Addendum 1 ITB #22-53-311675 Curry Ballast Production

Addendum number 1 has been issued for questions and closing date change.

Alaska Railroad Anchorage to Fairbanks Clearance Chart

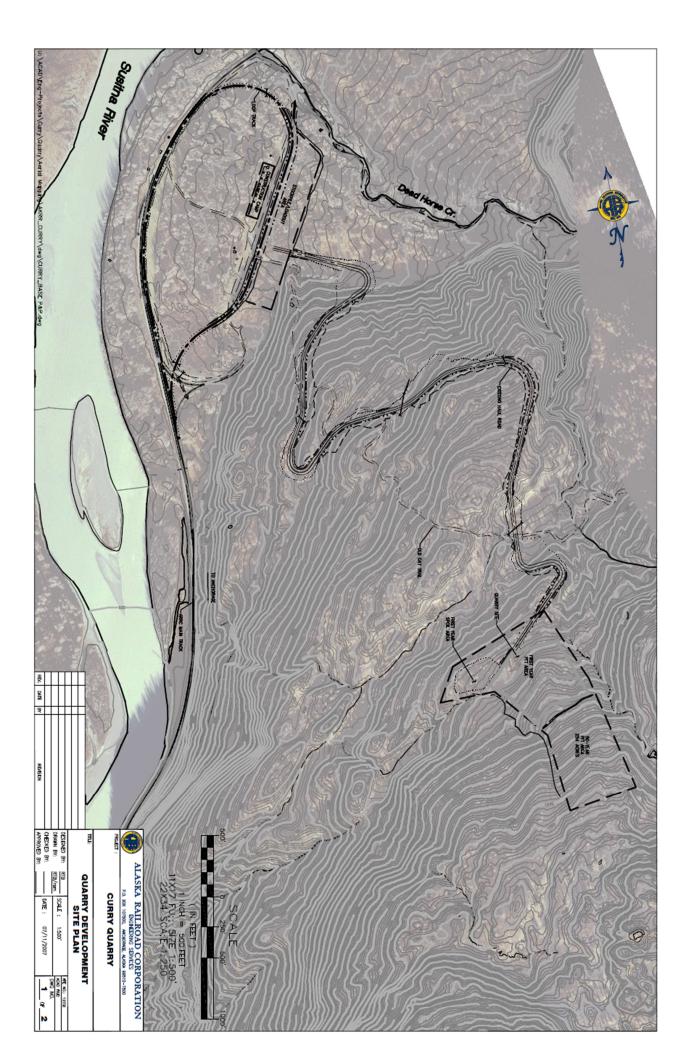
2. The ARRC Load Manual does not provide maximum width, height, and weight tolerances for getting equipment to Curry. Can you please advise?

Note that max width at the given height is above top of rail, ie loaded dimension. We usually assume a 3'9" ATR flat car deck height. See "Anchorage – Fairbanks Clearance Reference" provided, also attached on the ARRC webpage under this solicitation.

Typical flat car weight capacity is ~160k to 180k lb.
